Change Order

Ketchum Fire Station #1
107 Saddle Road, Ketchum, ID

Change Order Number: 008
Date: August 11, 2021

See attached spreadsheet of seven items.

6 PARAPET PLAN DETAIL @ GRIDS G & 1
SCALE | 1 1/2" = 1'-0"

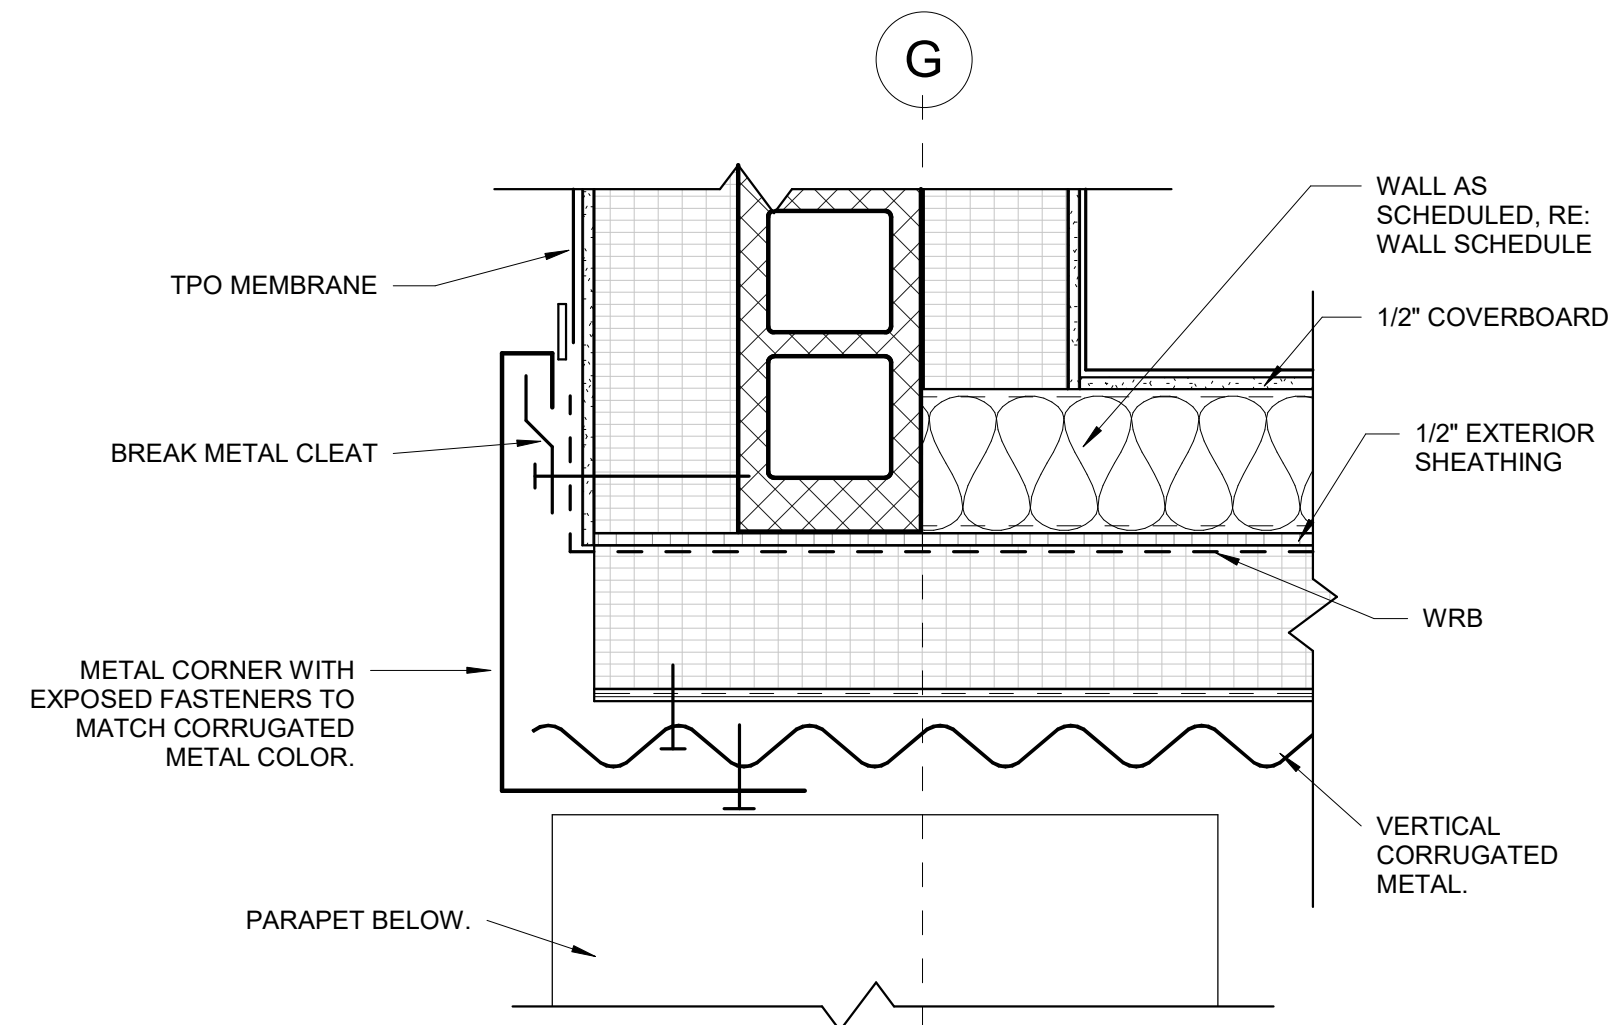
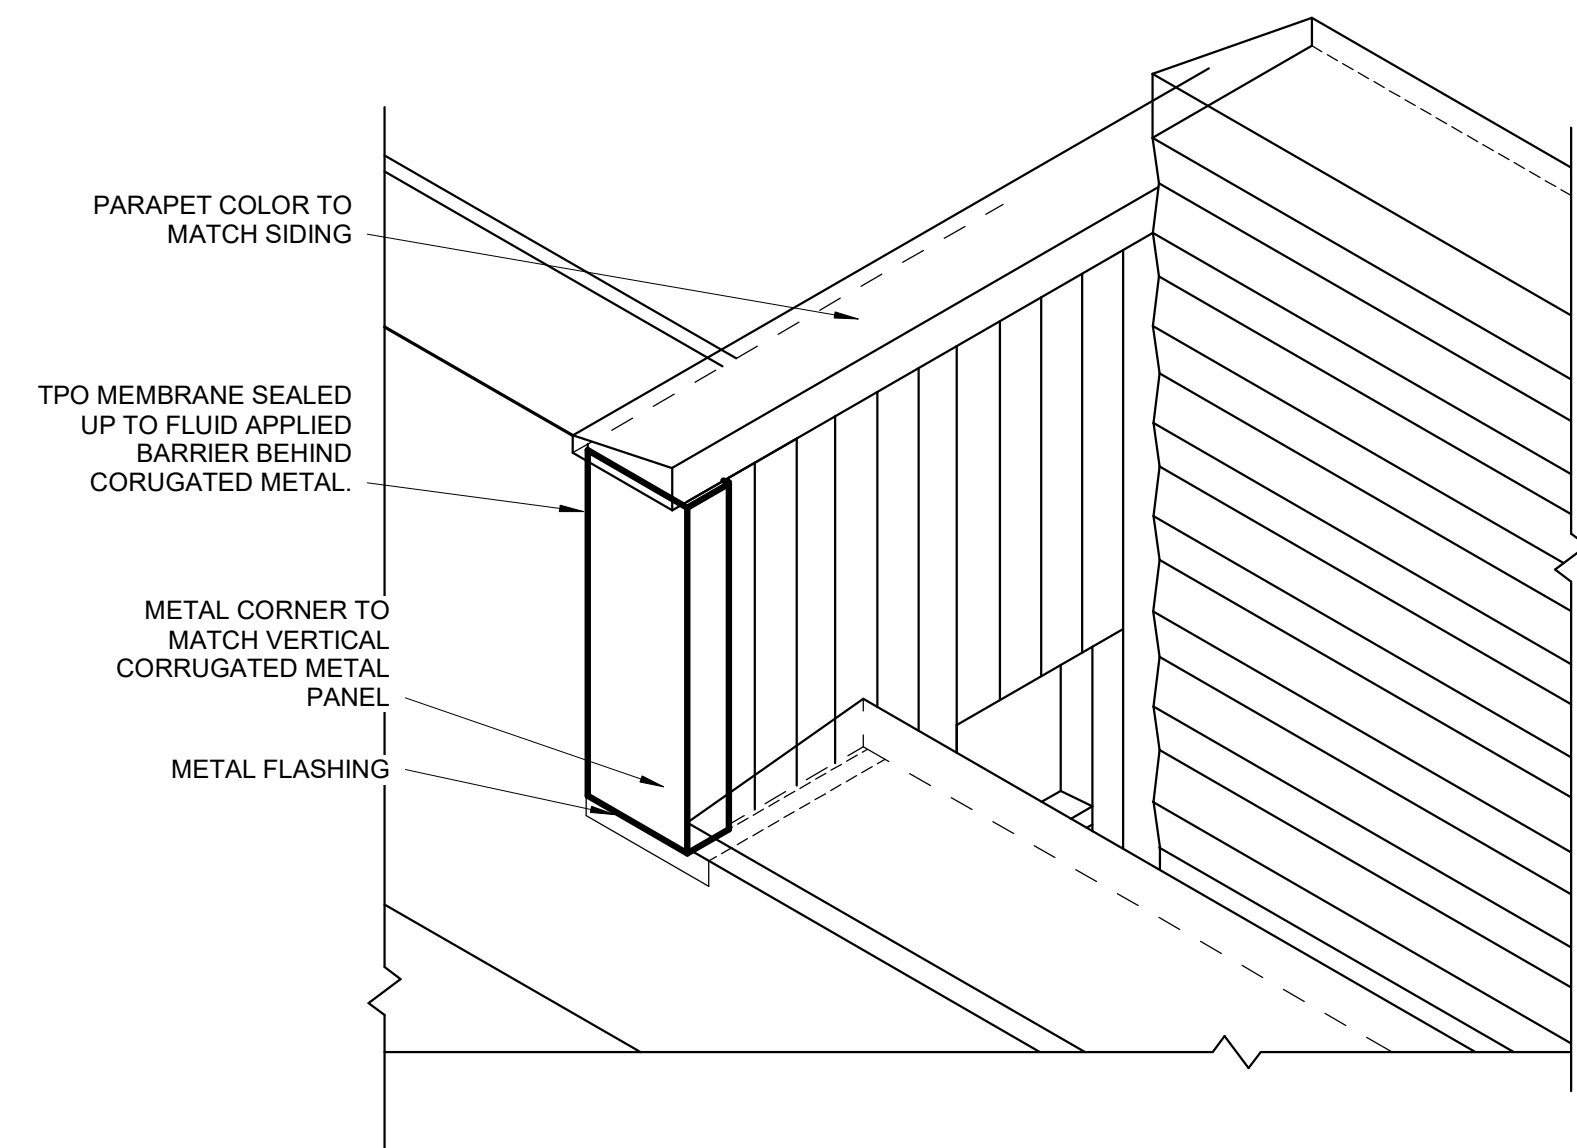
- 1) A3.00 – EXTERIOR ELEVATIONS
 - a) #1 – EXTERIOR ELEVATION – EAST
 - i) ADDED DETAIL CALL OUT.
 - b) #4 – EXTERIOR ELEVATION – WEST
 - i) UPDATED PARAPET HEIGHT.
 - ii) ADDED DETAIL CALL OUTS.
- 2) A7.00 – ROOF PLAN
 - a) ADDED FOUR DETAIL CALLOUTS FOR UPDATED DETAILS ON SHEETS A7.22 – DETAILS ROOF AND A7.23 – DETAILS ROOF.
- 3) A7.22 – DETAILS – ROOF
 - a) ADDED DETAIL #9 – PLAN VIEW PARAPET DEAIL @ GRIDS G & 5.
- 4) A7.23 – DETAILS - ROOF
 - a) ADDED DETAIL #3 – ISO PARAPET DETAIL @ GRIDS B & 2N.
 - b) ADDED DETAIL #4 – ISO PARAPET DETAIL @ GRIDS 5 & B.
 - c) ADDED DETAIL #5 – PLAN VIEW PARAPET DETAIL @ GRIDS B & 5.
 - d) ADDED DETAIL #6 – PARAPET PLAN DETAIL @ GRIDS G & 1.
 - e) ADDED DETAIL #7 – ISO PARAPET DETAIL @ GRIDS G & 1.

DESCRIPTION:	Per ASI #10- Furnish and install additional Vapor Retarder, Roof Insulation, DensDeck, Install new TPO Wall Flashings at modified wall area, install metal wall caps
DRAWINGS:	Per ASI #10- Wall between Gridlines B & G, Revised Drawings 6/16/2021 A7.23 Added Details #3,#4,#5,#6,#7

1 EXTERIOR ELEVATION - EAST
SCALE | 1/8" = 1'-0"

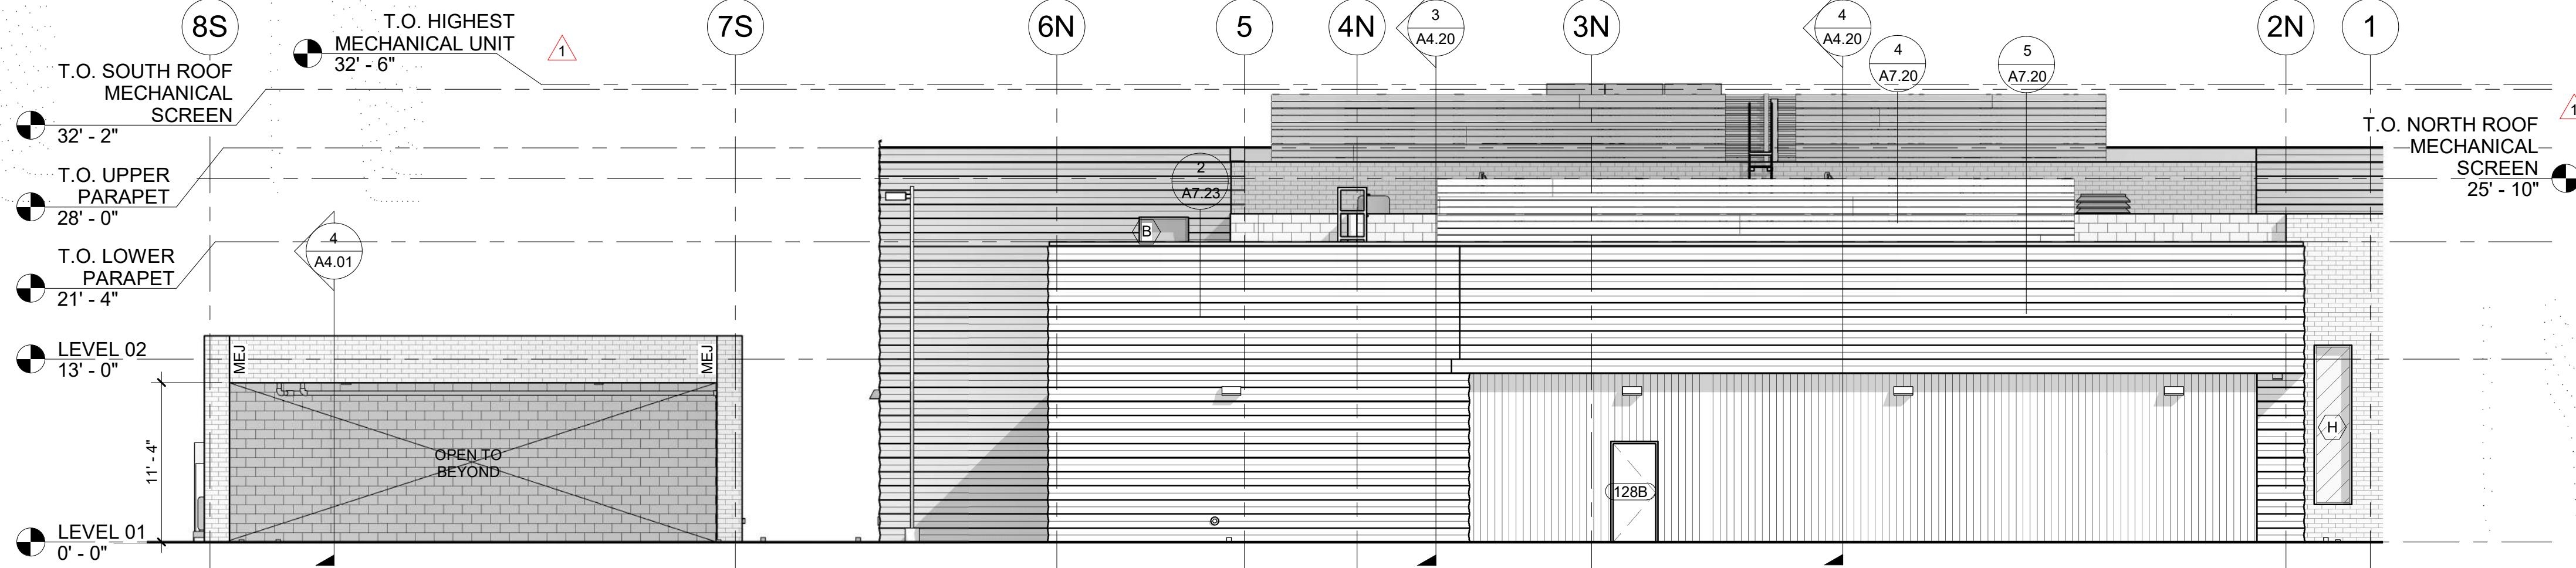
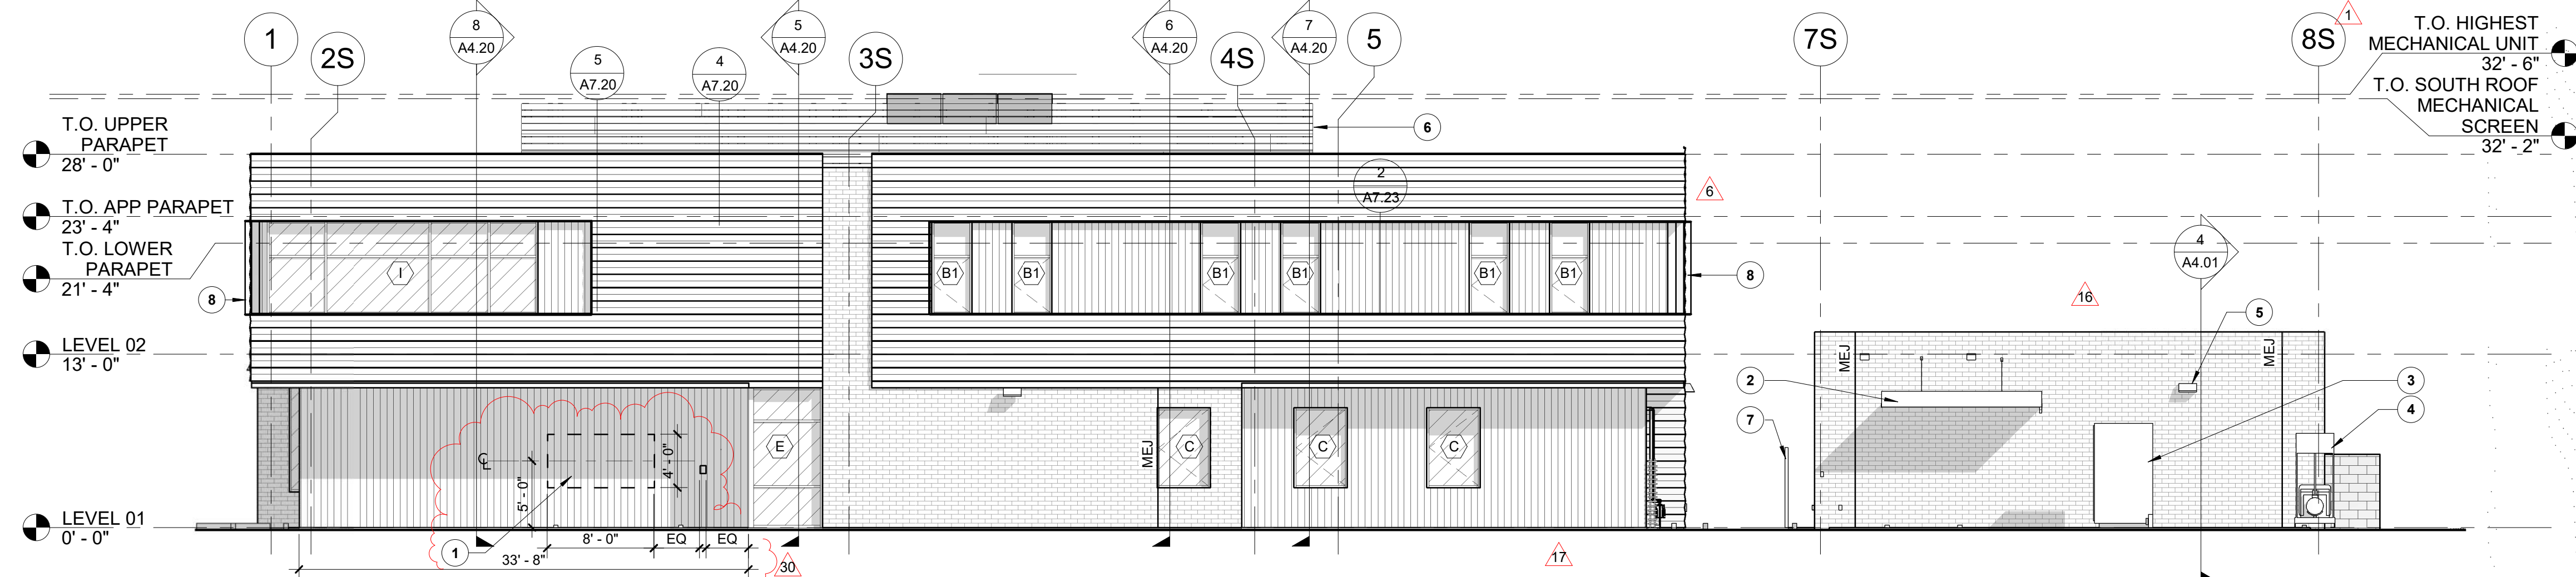
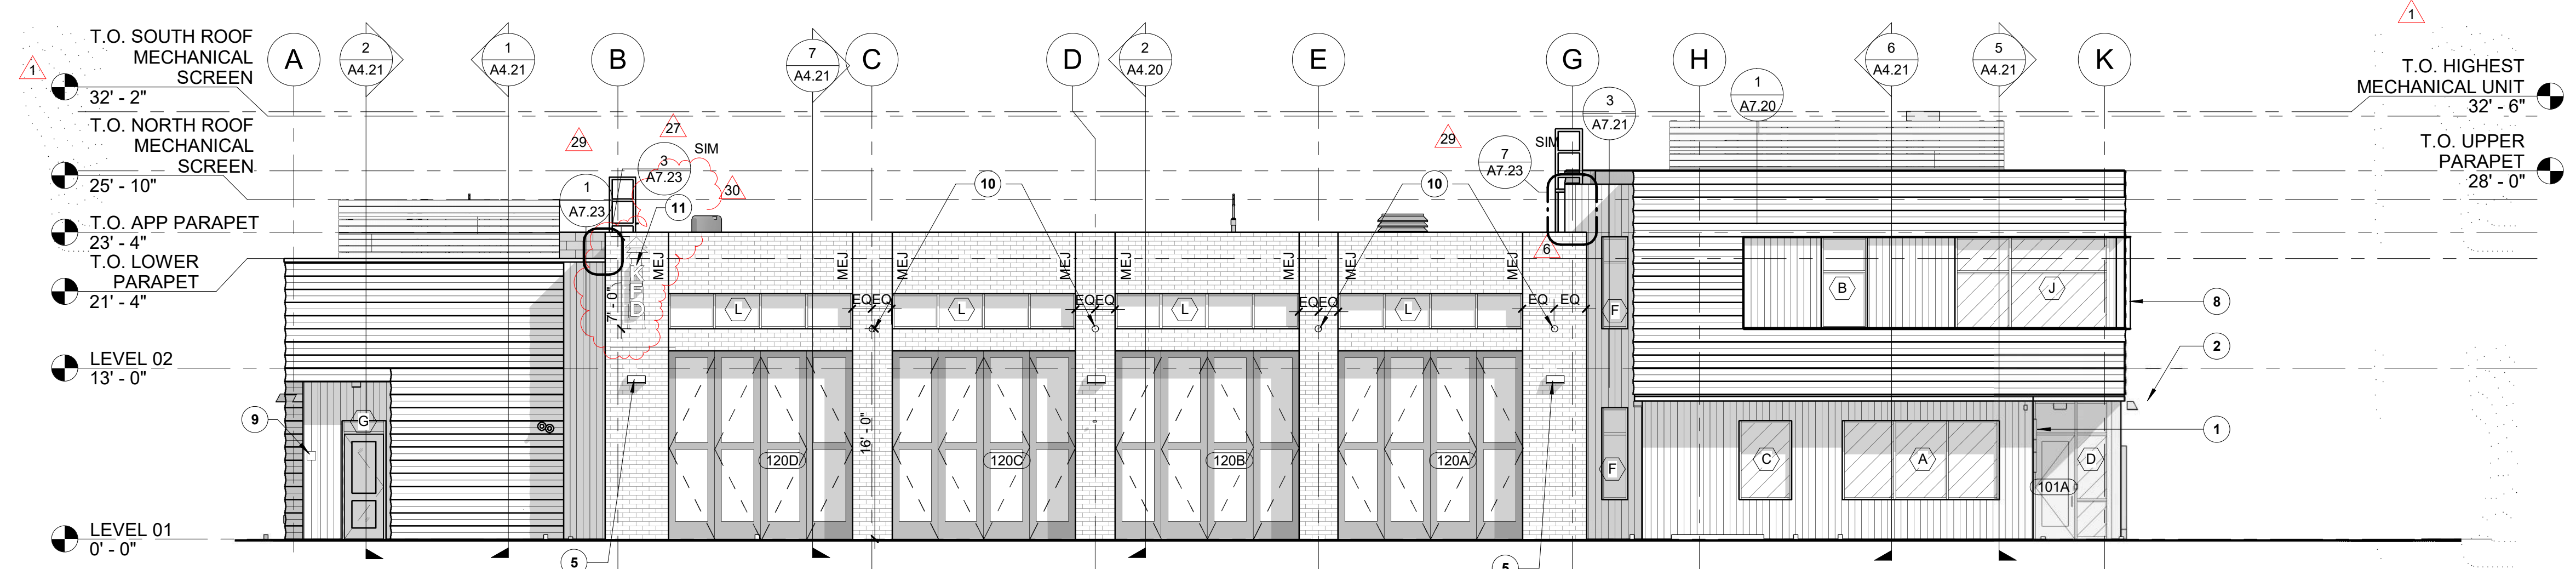
- 1) A3.00 – EXTERIOR ELEVATIONS
 - a) Updated Keynote #1
 - i) “PROVIDE BACKING IN WALL FOR EXTERIOR SIGNAGE. EXTERIOR BUILDING SIGNAGE TO BE OWNER PROVIDED.”
 - b) Added Keynote #11.
 - i) “EXTERIOR MOUNTED HISTORIC STATION SIREN, OWNER PROVIDED. DECORATIVE ONLY.”
 - c) #3 – EXTERIOR ELEVATION – SOUTH
 - i) Removed exterior signage.
 - ii) Added exterior signage backing and dimensions.
 - d) #4 – EXTERIOR ELEVATION – WEST
 - i) Added exterior wall mounted historic siren.

1ST FLOOR DETAIL AT ELEVATOR WALL

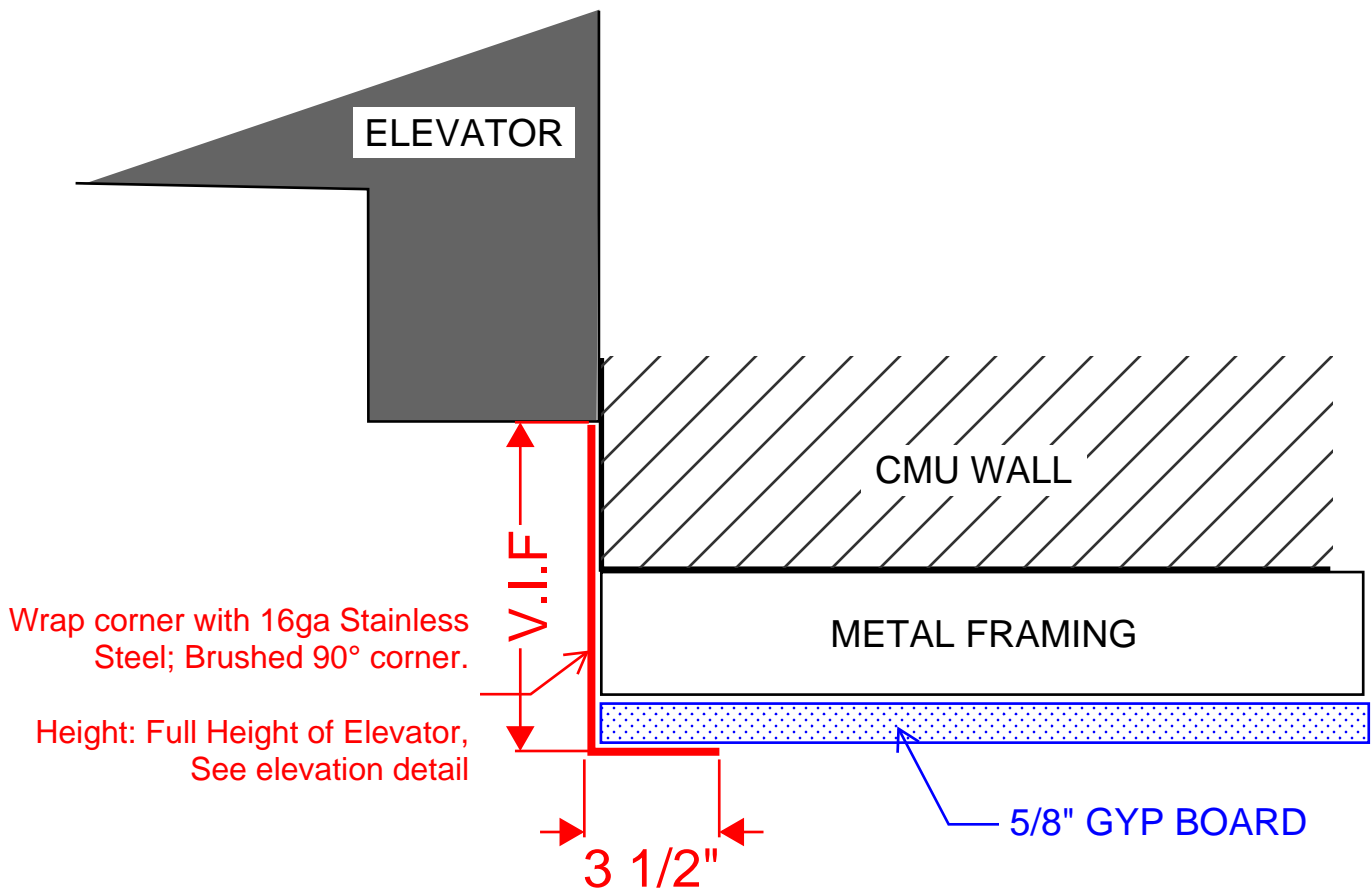
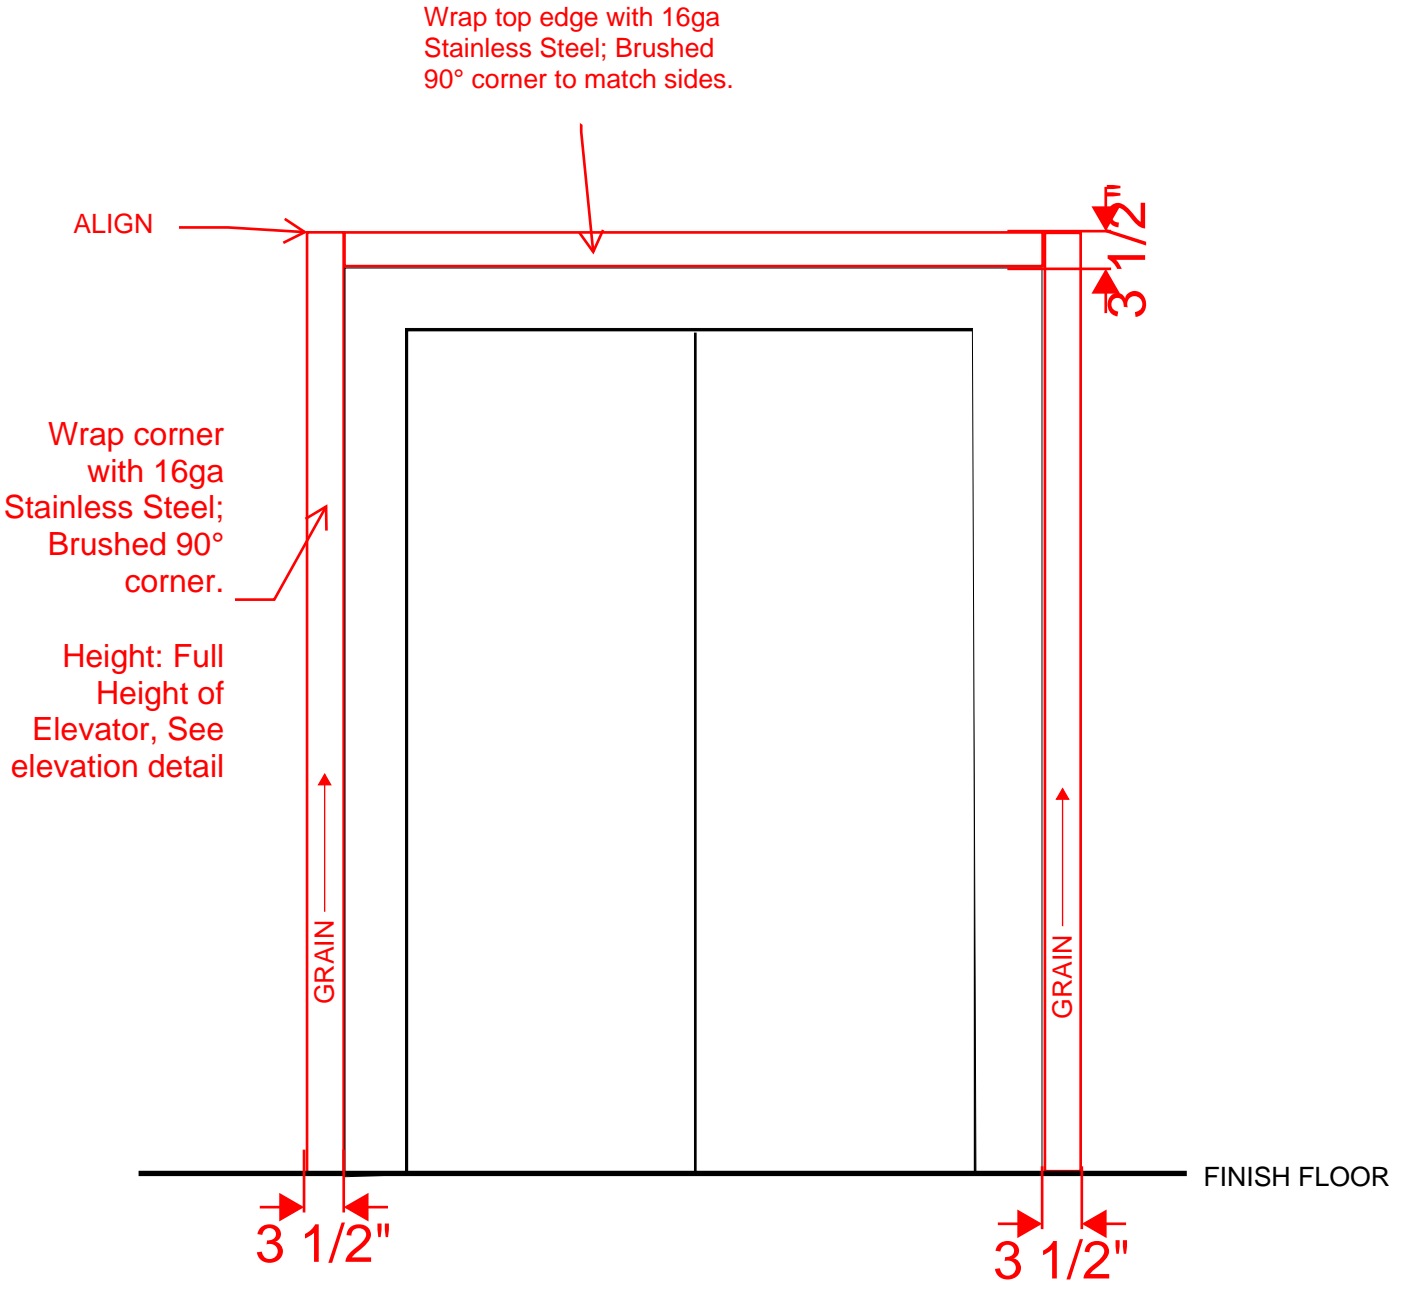
Question from JT Brown CORE Construction - Las Vegas on Wednesday, May 26, 2021 at 10:05 PM MDT
 Per the approved Elevator shop drawings the elevator frame is less than 8 inches wide and the masonry is solid grouted into the frame. Please confirm that the framing and 1/4" drywall wrapping into the frame is acceptable.

Wrap sides and top of frame walls around elevator on 1st and 2nd floor with 16ga Stainless Steel; Brushed 90° corner. See two attached PDFs with details.
